RE: **SAD 228 Volcano Cliffs Unit 18**
6601 Sujeto NW Lot 33 Block 6
Grading and Drainage Plan Date 4/26/2021 (D10D003M33)
CO Approval Date 12/18/2023
Revised G&D plan for pool Date: 5/27/2025

Based upon the information provided in your submittal received 5/27/2025, this plan is approved for a revised Grading Permit for a pool, and will now be the plan of record.

ENGINEER'S SEAL  5/20/25 7/26/21 DAVID SOULE P.E. #14522	6601 SUJETO	DRAWN BY: WCWJ
	GRADING AND DRAINAGE PLAN	DATE: 7-21-21
 Rio Grande Engineering 1606 CENTRAL AVENUE SE SUITE 201 ALBUQUERQUE, NM 87106 (505) 872-0998		210210071-LAYOUT-7-21-21
		SHEET #
		JOB # 21021071

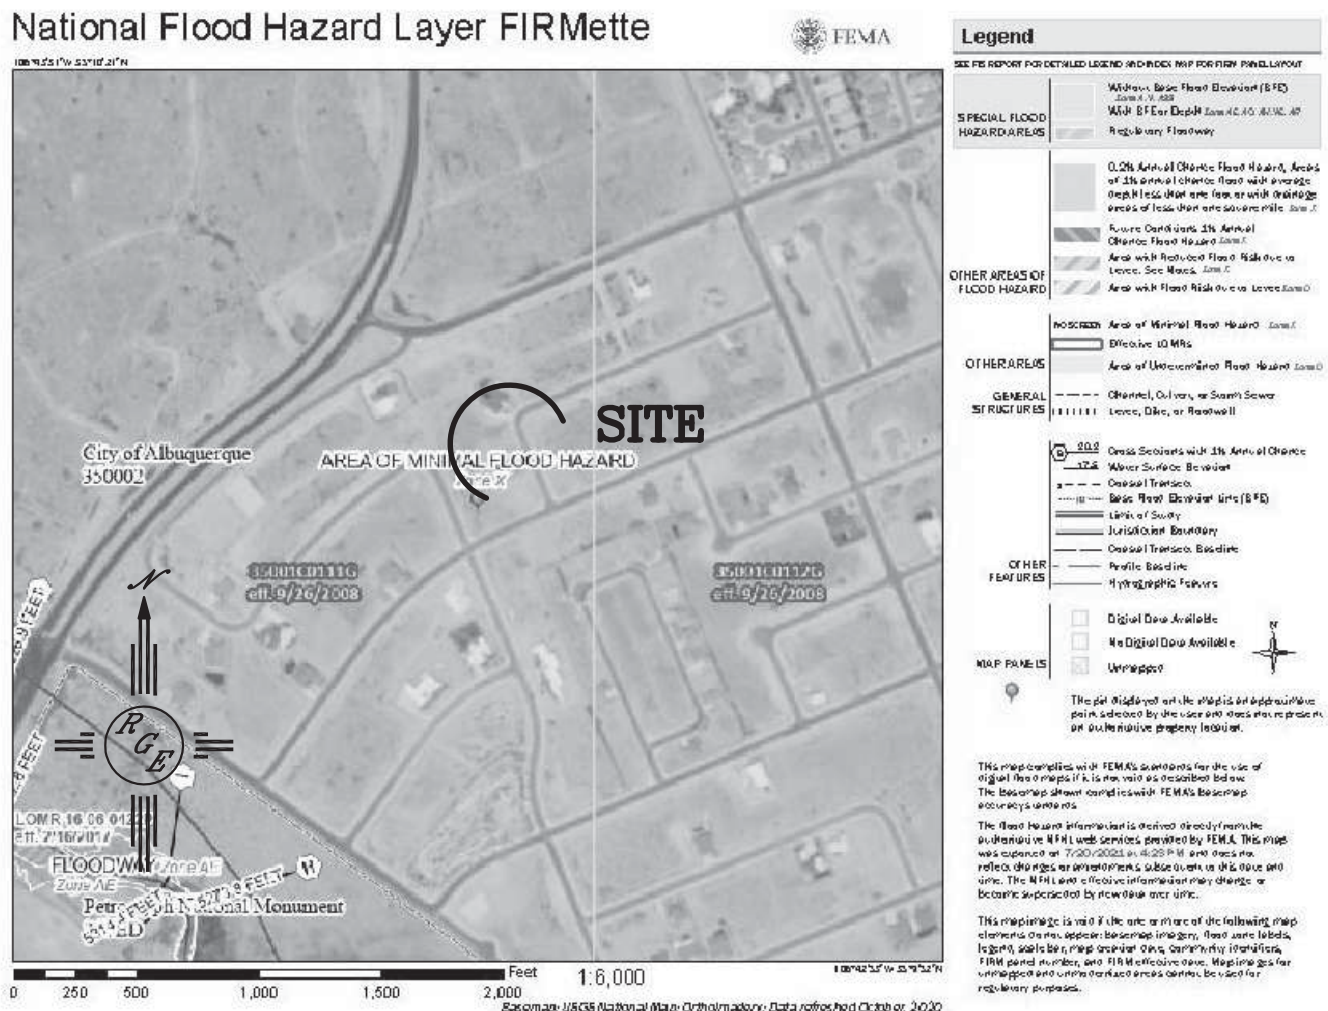
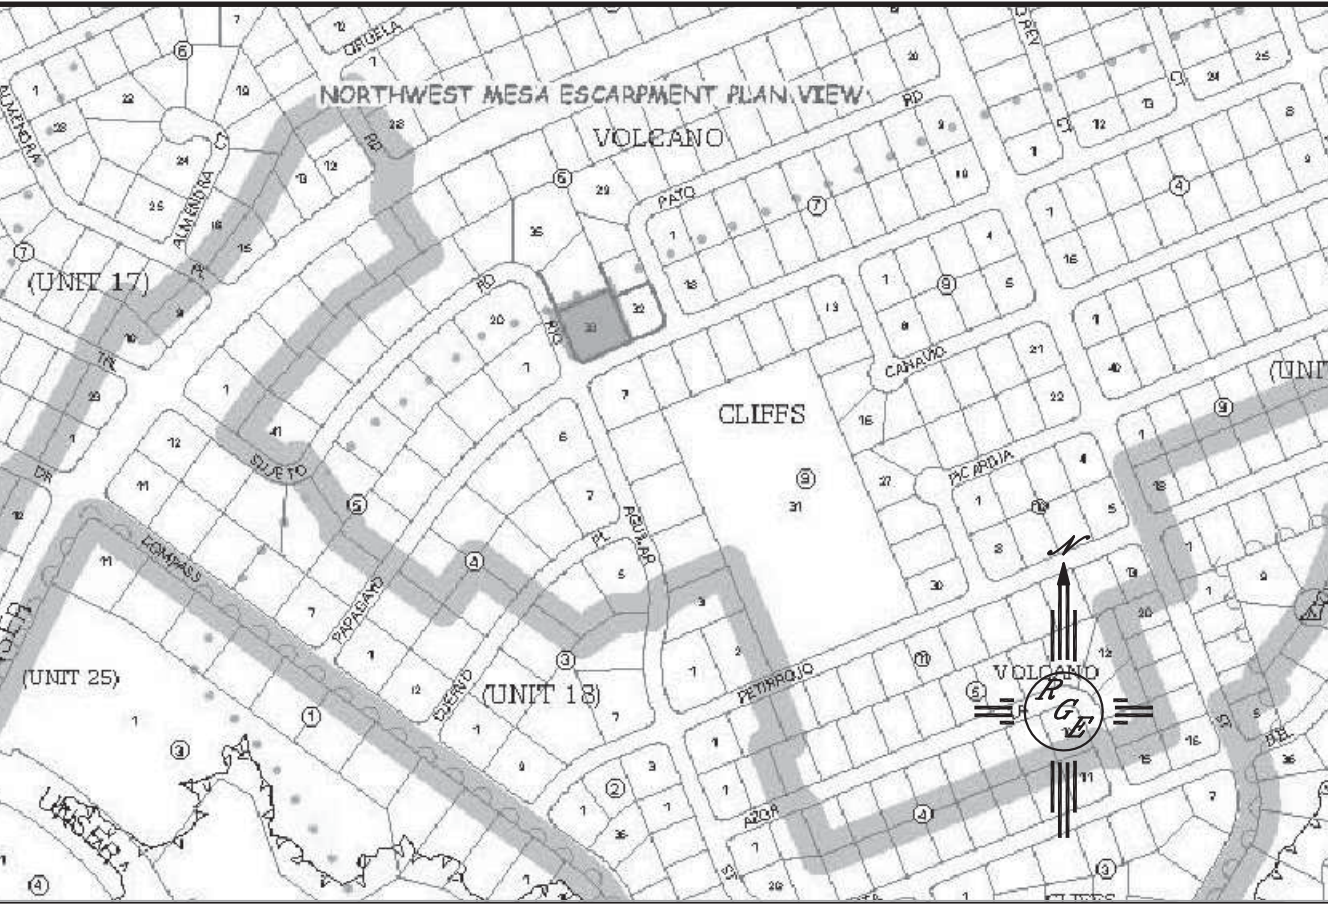
Engineer Certification per the DPM checklist is required.
